APPENDICES

DOCKET 272

Re: Draft D&M Plan; Segment 2a

BY	JMH - BMSB	CHKD	APP	DATE	DATE
SCALE	N.T.S.	MICROFILM DATE	DWG. NO.	XS-001	FIGURE 7AB
P.A. #

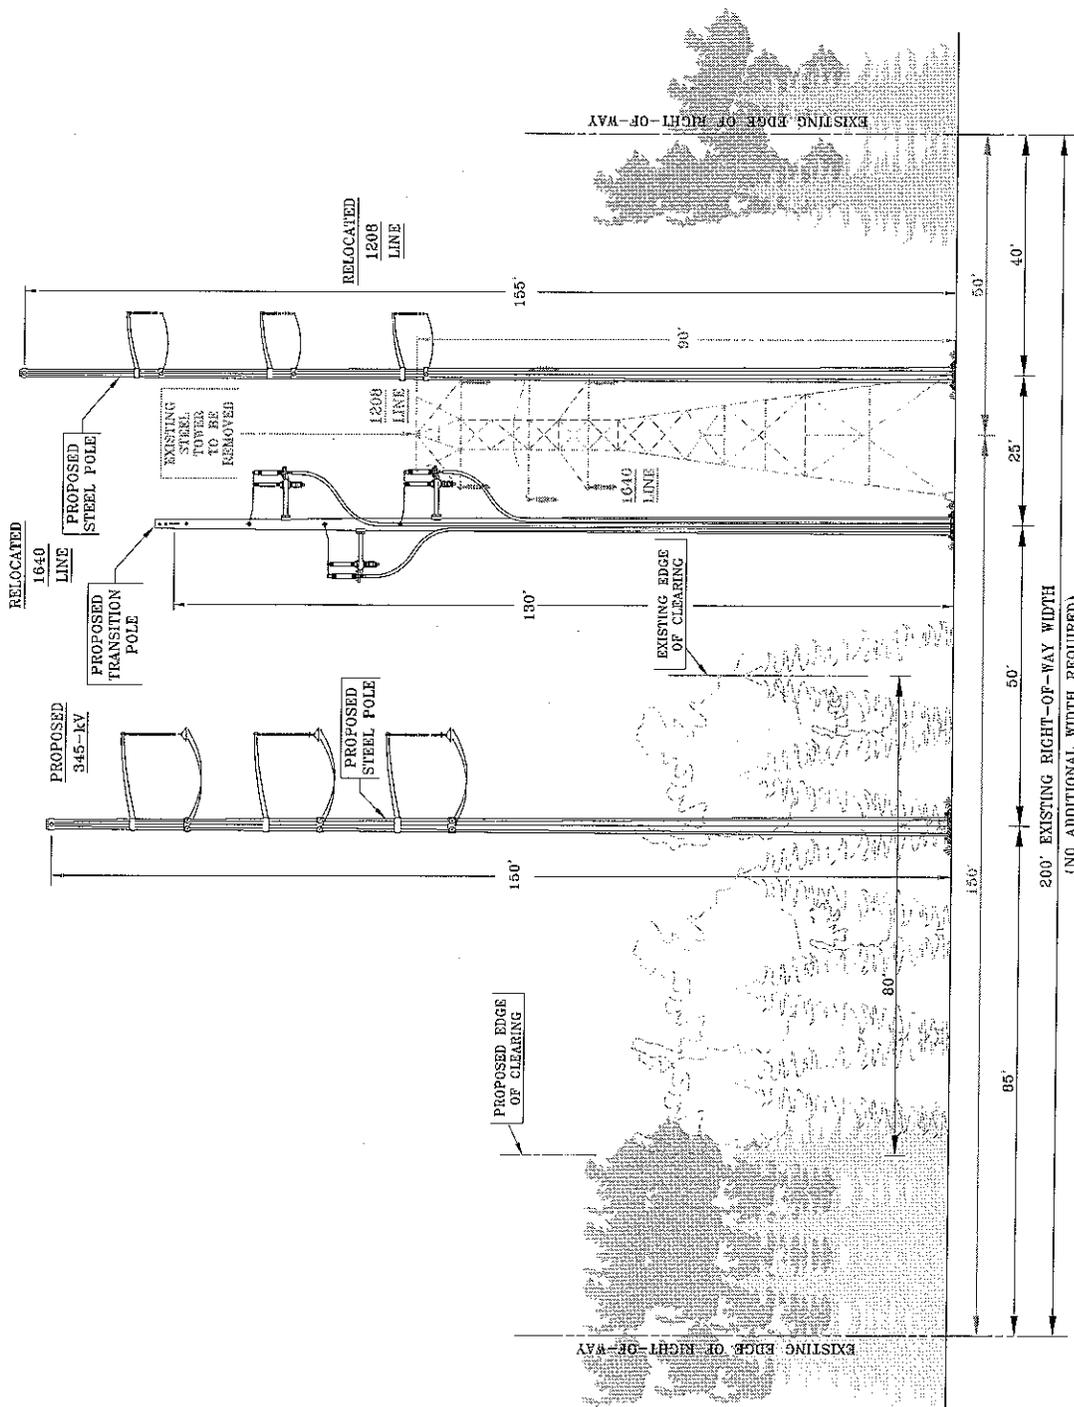
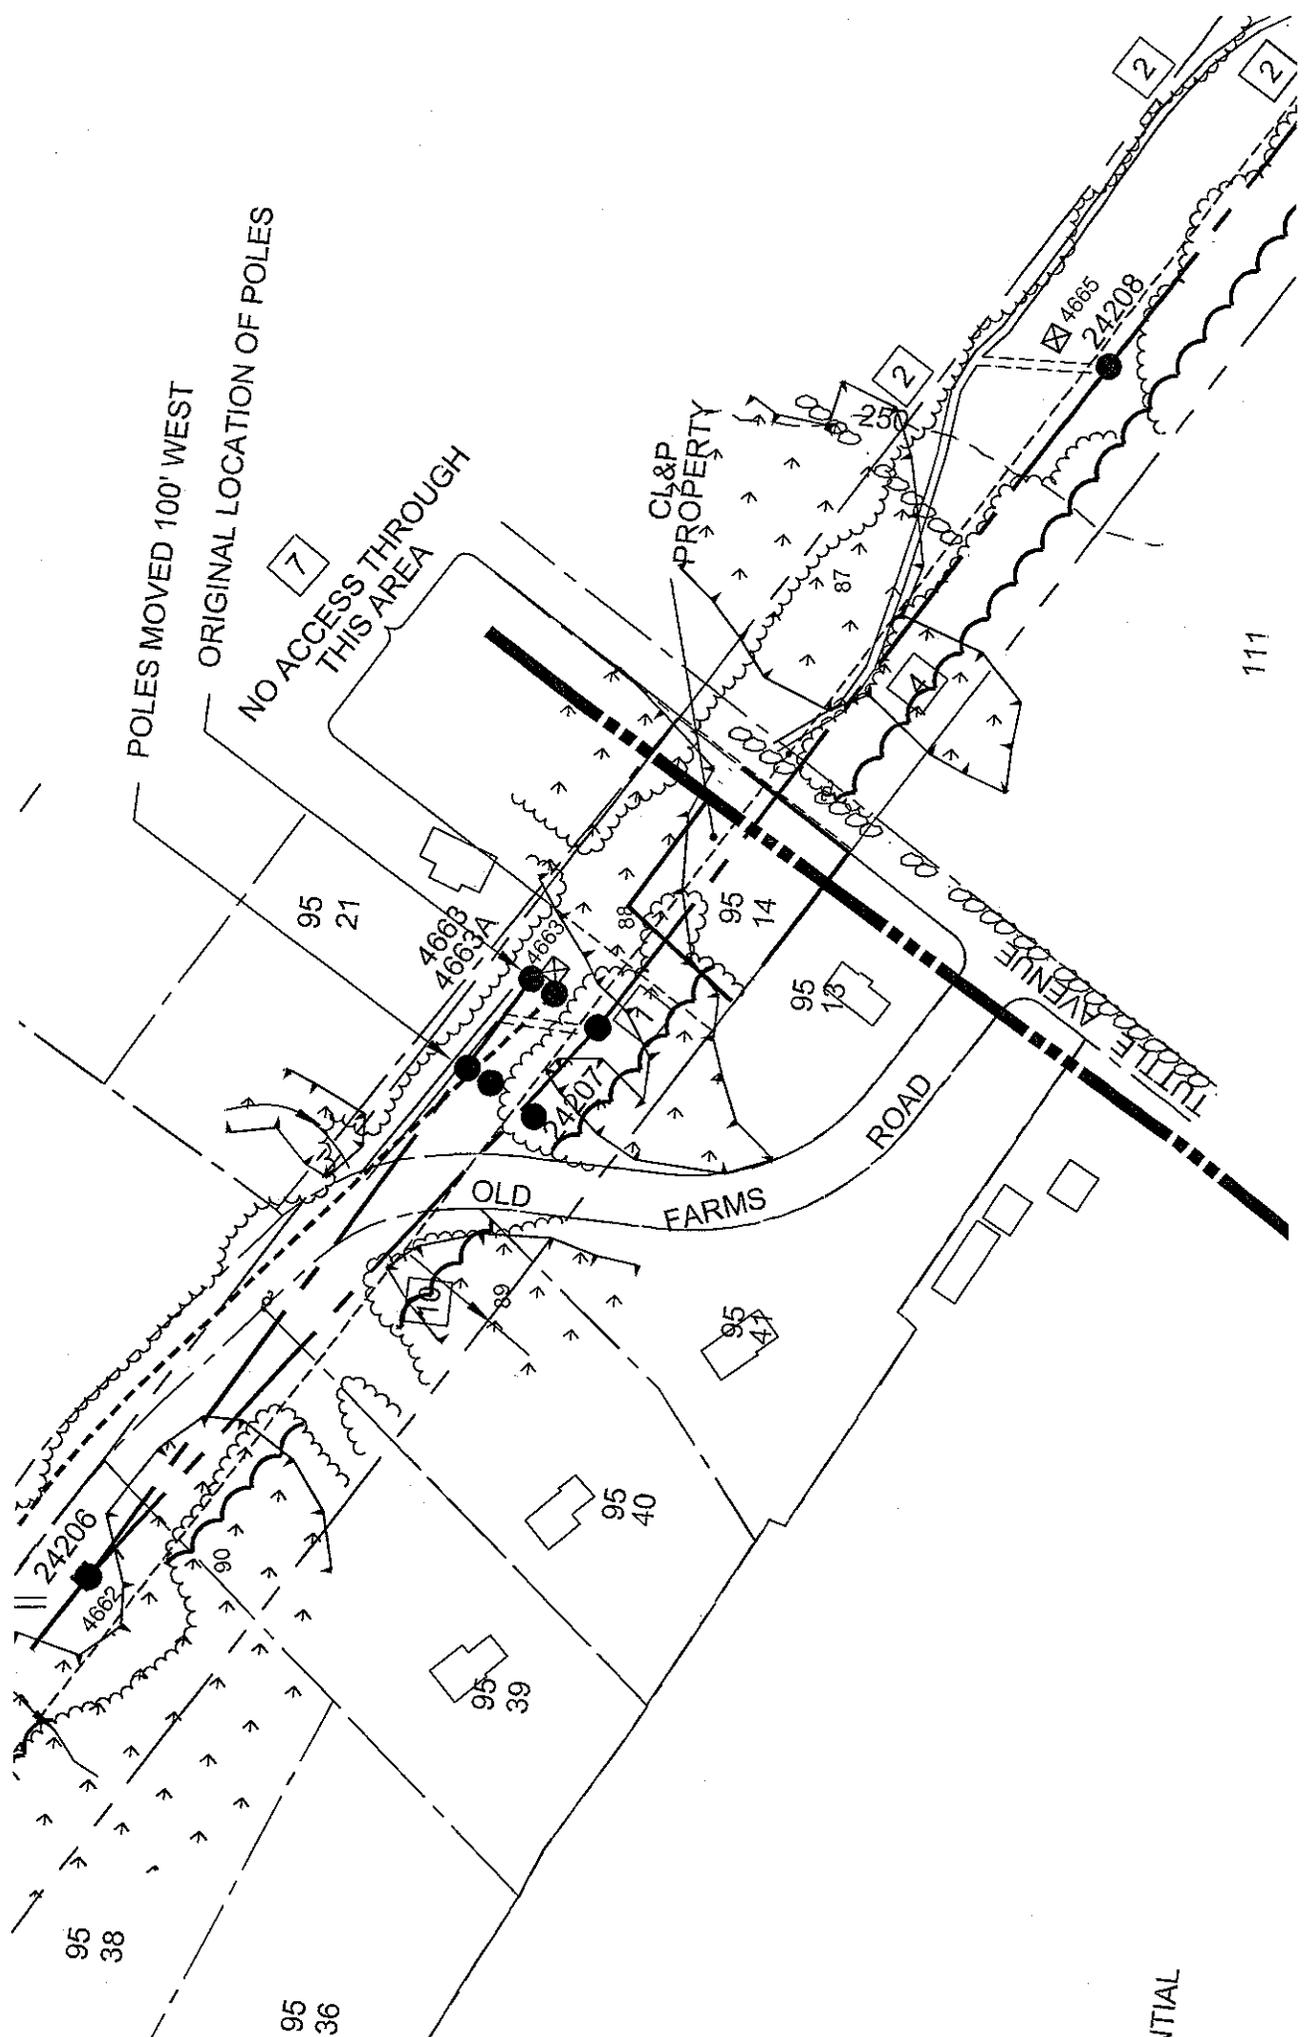
I have a question about the transition pole in Cheshire. Do you have a drawing that depicts the transition for the 115KV line near Tuttle Avenue(plan and profile)? How much area is required for the OH/UG conversion structure Ray?

Pat, Thanks, but I was looking for a detailed drawing that showed the riser pole configuration. Fairly detailed. For example, is there any switch included, on the pole (unlikely) or adjacent? Etc. etc., Do you have a photo of a similar transition pole? My thinking is that the structure will take up quite a bit of space compared to a tangent pole.

The conceptual pole drawing is not yet complete. Attached is the cross section (7AB) for the transition structure as shown in the latest D&M Plan. The diameter of the foundation and pole is expected to be about 2 feet more on a transition structure vs. a tangent.

This cross section is for the transition structure being located in Cheshire. The heights of the structures will change if the location of the transition structure changes.
